SERVICE BULLETIN

15-T4-71

MODELS CONCERNED: All MK4 B, C, F & T Series Tractors & XRD Decks.

CONCERN: In certain operating conditions it may be possible for the deck drive belt to jump off the pulleys due to the front tensioner becoming disengaged.

Deck Input Pulley:

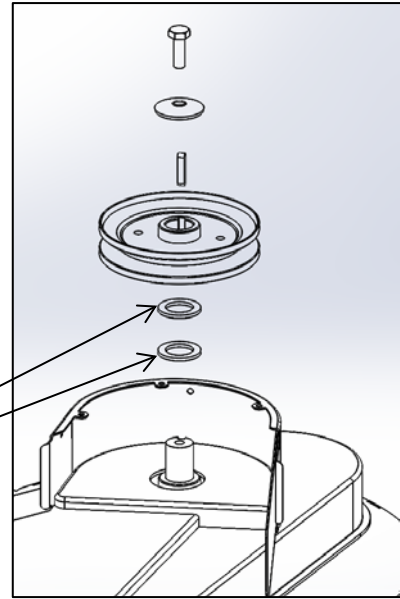
1. Addition of shims to deck input pulley.
2. Replace sleeve on deck tension lever.

Adding shim to the deck input pulley. Remove deck from the machine following the instructions in the operator manual and place in a safe working position.

1. Remove M10 bolt & dome washer.
2. Slide off pulley & key.
3. Place new shims over the top of the shaft.
4. Put back pulley, key, dome washer and re-tighten M10 fixing bolt to the correct torque.

Additional Shim x 2
549011500

Tension Sleeve:

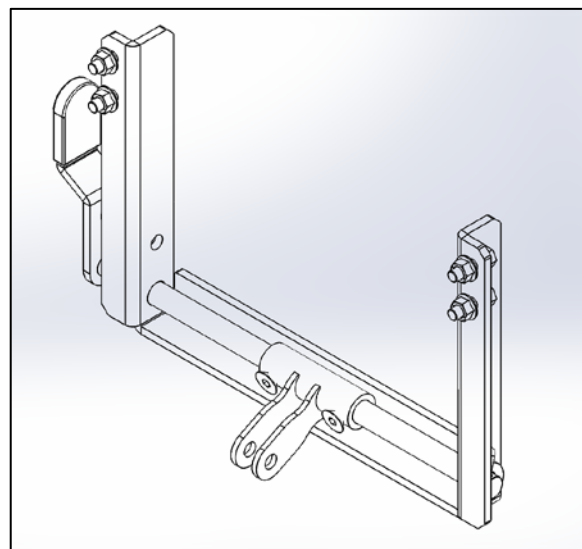
Remove the existing tension handle sleeve and replace with the revised version. Make sure the machine has fully cooled down before attempting to replace the tension sleeve due to the close proximity of the exhaust muffler.

1. Loosen & remove the 2 off screws holding the sleeve to the handle shaft.
2. Remove clip & washer from non-handle end of shaft.
3. Slide the handle assembly out of the support frame until the existing sleeve can be removed & replace with the new version.
4. Slide handle back through the support frame hole and replace the washer & clip.
5. Line up the sleeve holes with the holes in the handle taking note of orientation as below.
6. Refit screws with Loctite 268 or equivalent & ensure the handle rotates freely.
7. The deck can now be refitted to the tractor using the existing tension bar.

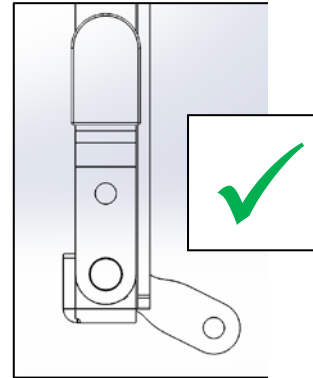
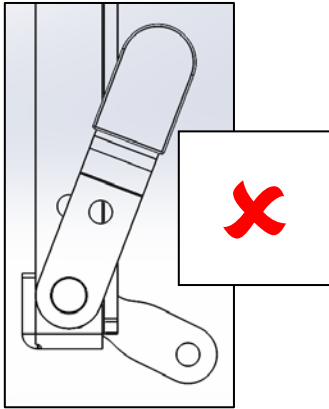
Please note that the sleeve plates are offset to the holes. Ensure that when it is in the tension position the alignment is per the RH image shown below.
